American Gilsonite Company

Re: Purposed changes to the sealing of escapeway shafts at H-2, H-10 and R-4 sites

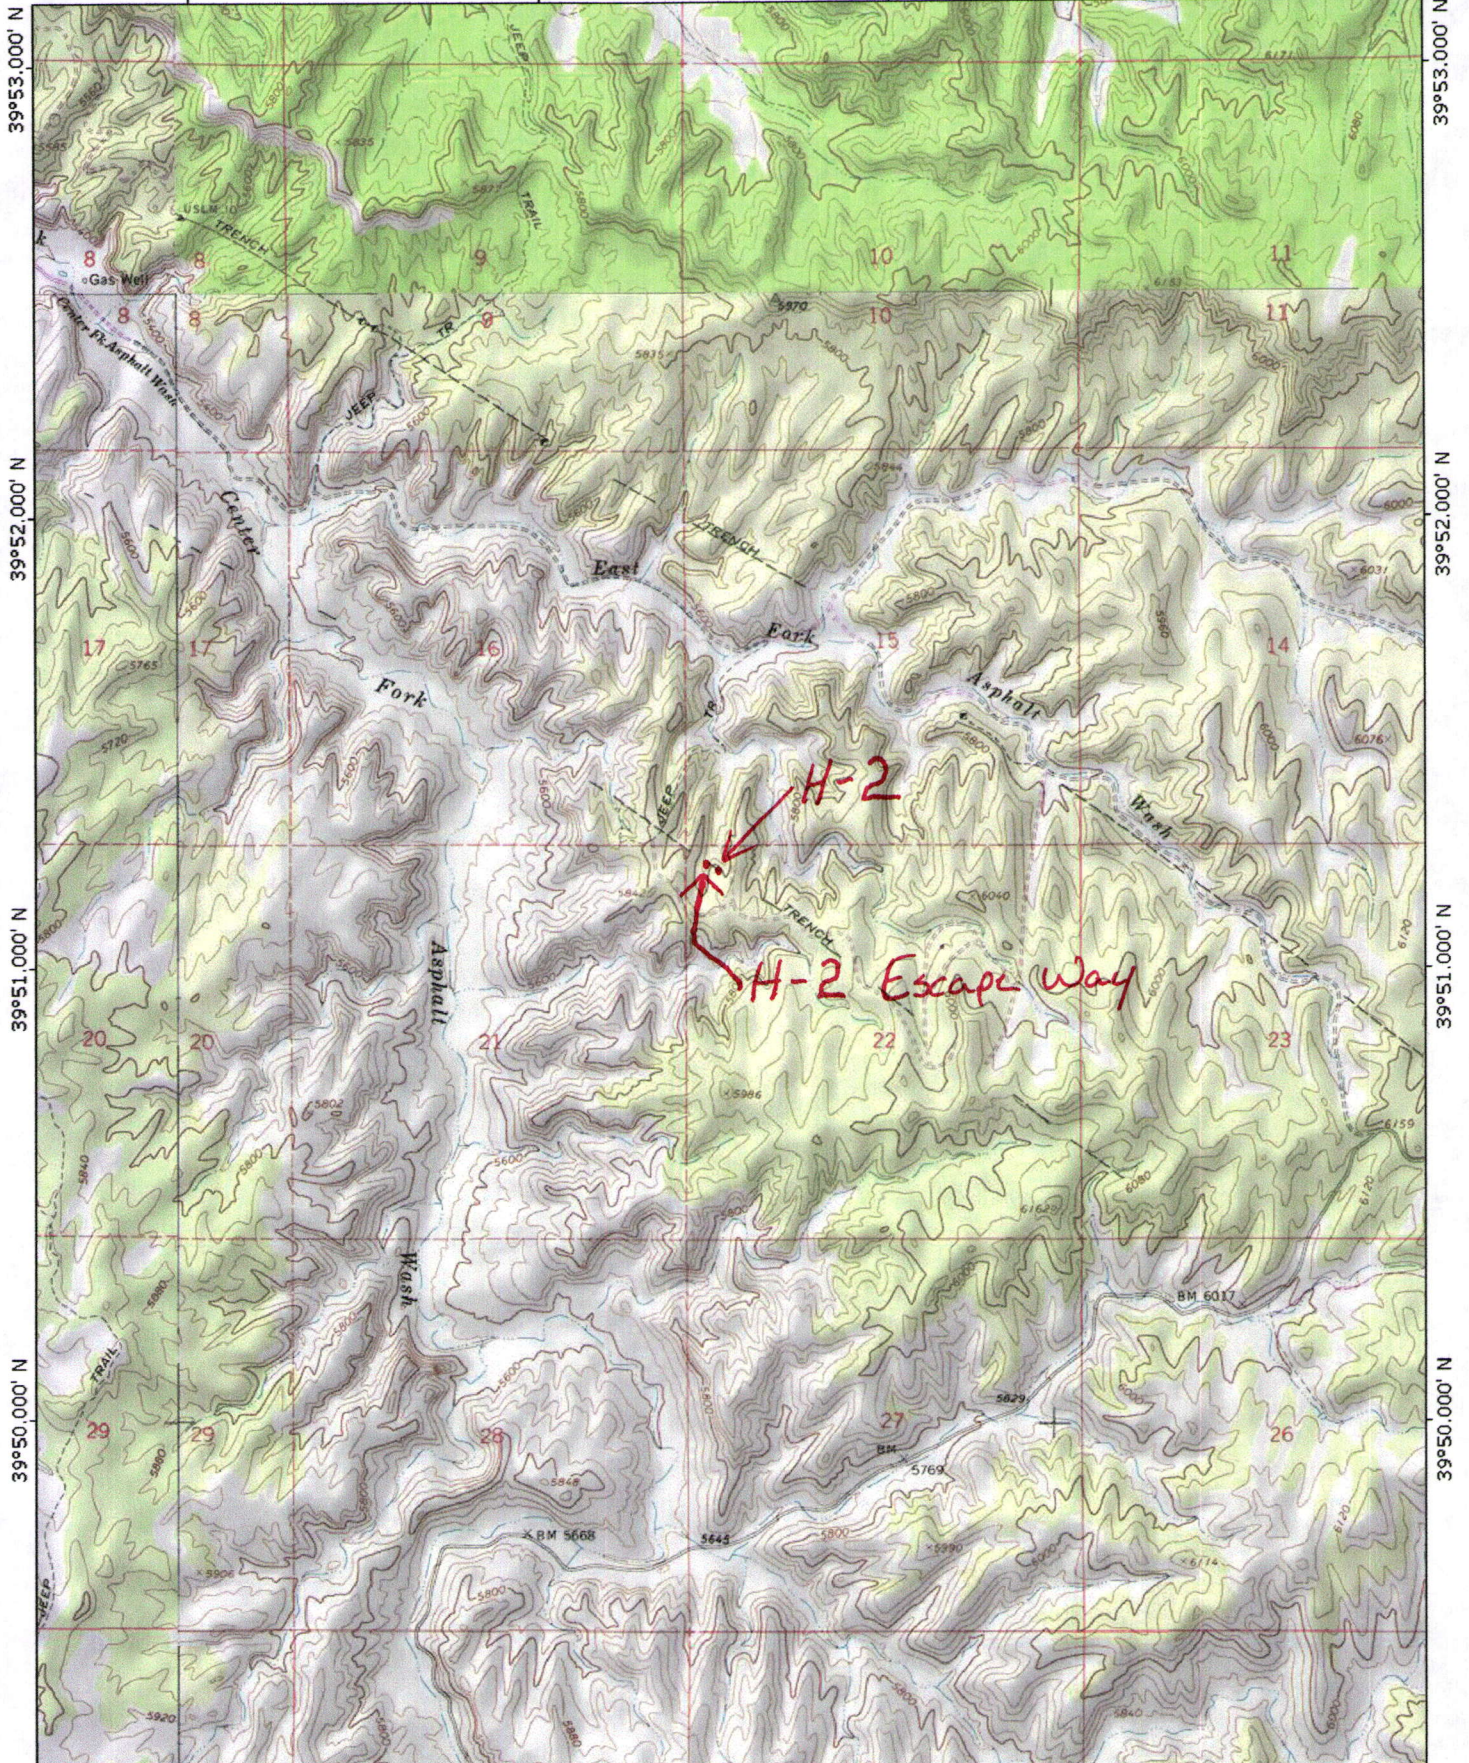
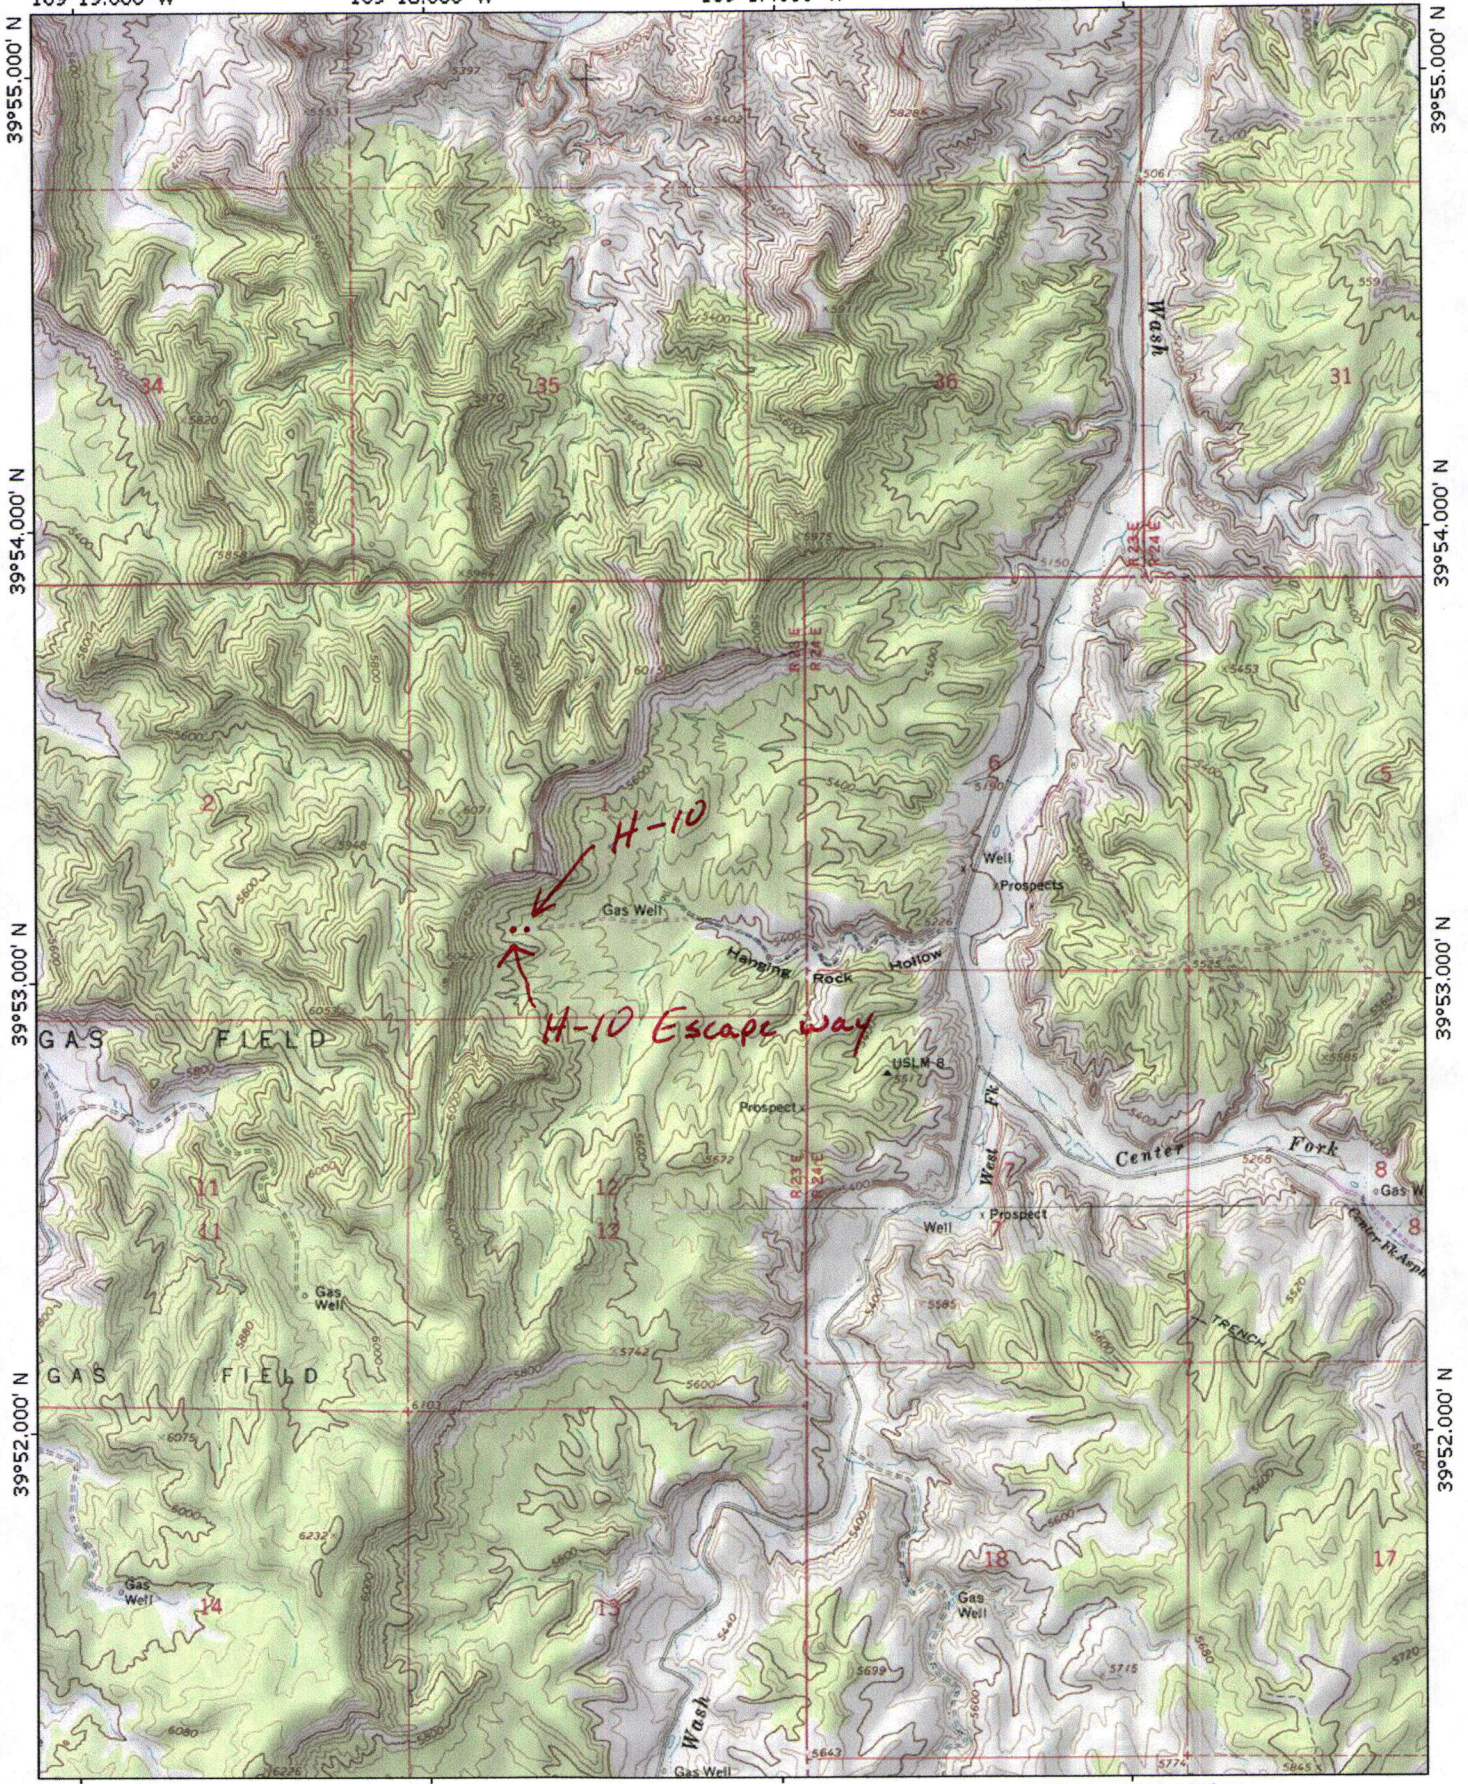
The location of the H-10 site is located in the NE ¼ of the SW ¼ of Section 1, Township 11 South, and Range 23 East. I have included 2 TOPO maps the showing the escapeway shafts at H-2 and H-10.
